MEMORANDUM

SUBJECT: South Pond Village Alternative Plan (DB-1)

SOUTH POND VILLAGE
 SITE PLAN
 OVERALL SITE LAYOUT PLAN WITH NATURAL FEATURES OVERLAY

Re: South Pond Village – HRD Submittal #2 – Resubmittal July 29, 2015

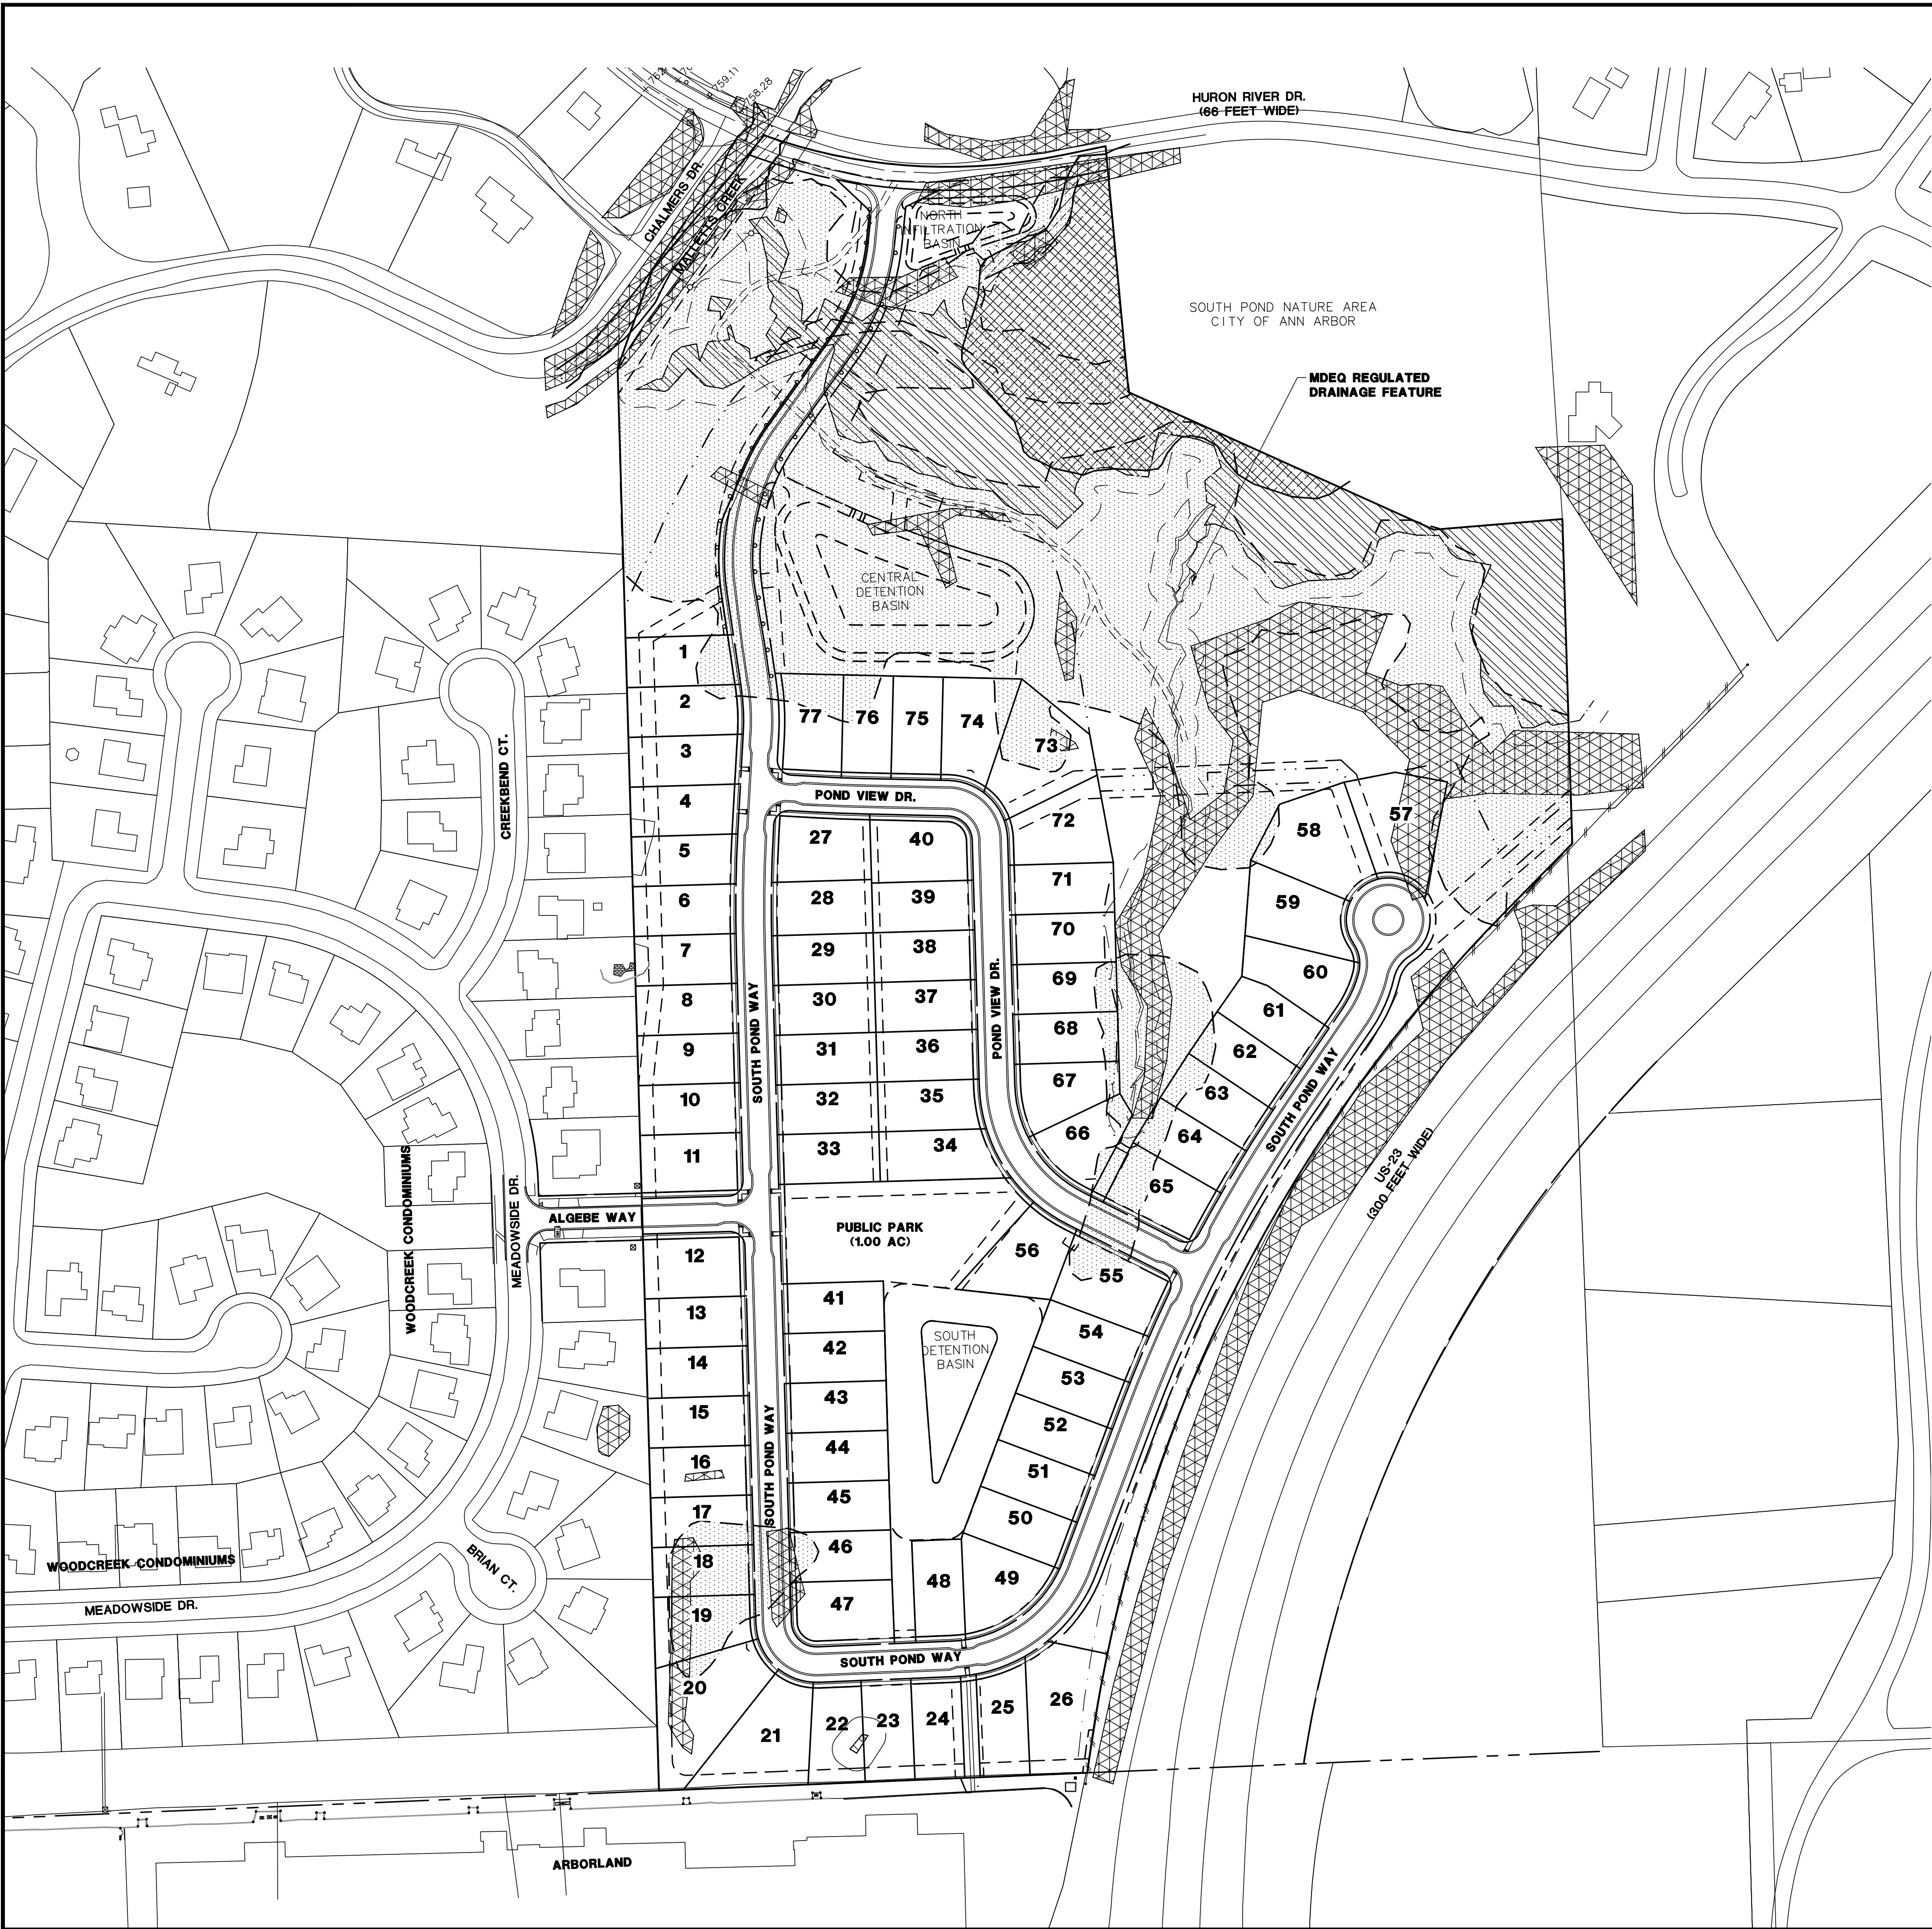
Staff does not support the alternative plan because more natural features are impacted through this layout, particularly related to wetland and wetland buffer impacts, and there is a reasonable alternative that would limit the disturbance to the natural features on the site. The original plan (with access off Chalmers/new west connection) limited natural features disturbance to the minimum necessary for the reasonable use of the property while protecting the high quality natural features on the north side of the site. The chart below summarizes natural features

NAP staff strongly opposes the construction of an access road from the development north to Huron River Drive. The proposed road would be built very close to areas where rare plant and animal species have been documented, including *Euphyes dukesi* (Duke’s skipper), which is state-threatened and legally protected, and *Carex trichocarpa* (Hairy-fruited sedge), which is a species of special concern Michigan. It is likely that construction activities so close to the wetland will have negative impacts on these species and their habitats.

South Pond Way is shown as the only exit for residents of this development and has the potential of becoming blocked by emergency vehicles. For that reason, South Pond Way from Huron River Drive to Pond View Drive shall be widened to create a boulevard.

As the site is proposed to have only one vehicular access, South Pond Way should have a boulevard cross section between East Huron River Drive and Pond View Drive to facilitate continued access in and out of the neighborhood in the event of an emergency response or other situation affecting traffic access within this area. As proposed, if South Pond Way were to be blocked due to such an event, residents would not be able to leave or enter the neighborhood until the event ended and the roadway was again cleared.

The proposed intersection with Huron River Drive is very close to the existing intersection at Chalmers Road. The engineers shall show that the intersection spacing meets guidelines for access management and that the proposed intersection will meet all sight distance design standards. The proposed cross-section for the roadway approaches Huron River Drive has unrecoverable roadside design. This situation is undesirable and the engineers shall develop a plan to mitigate this concern.
